Appl. No.: 10/602,982
Amdt. dated 08/18/2005
Reply to Office action of August 18, 2004

Amendments to the Drawings

REMARKS

FIG. 1

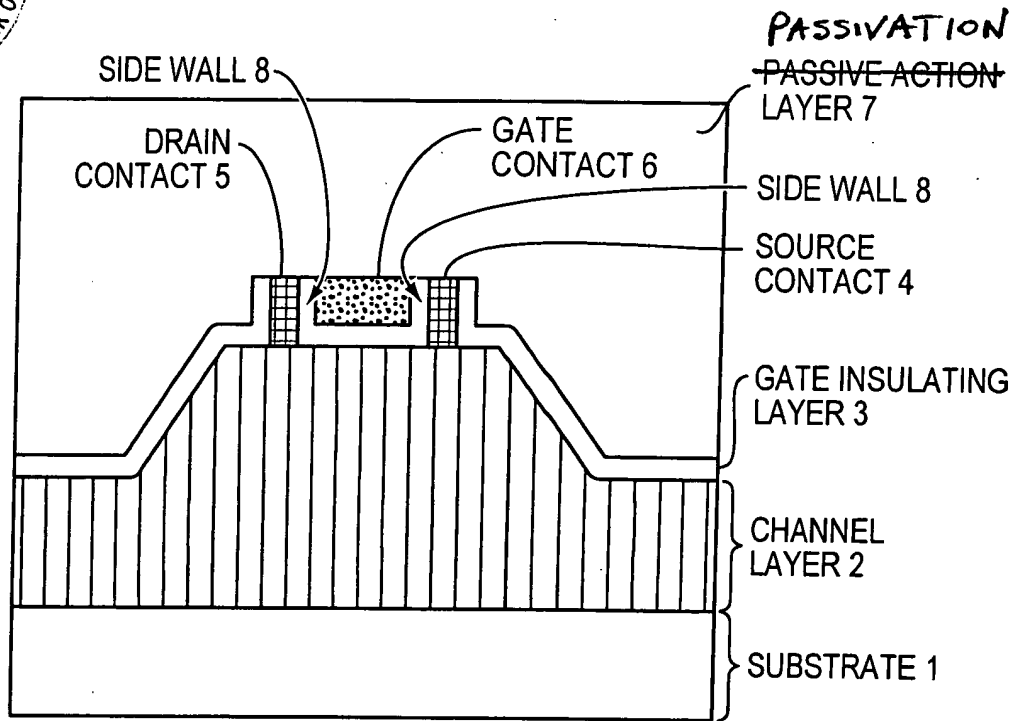
On page 2, item 1 of the Office action, FIG. 1 was found objectionable for stating "passive action layer" rather than "passivation layer." The attached replacement sheet overcomes the objection. Entry of the replacement sheet in the subject application and withdrawal of the objection are requested.

FIG. 1 has been amended to change “passive action layer” to “passivation layer” as indicated in the mark-up version of FIG. 1 attached as an Appendix. A replacement sheet for FIG. 1 with the requested change is also attached.
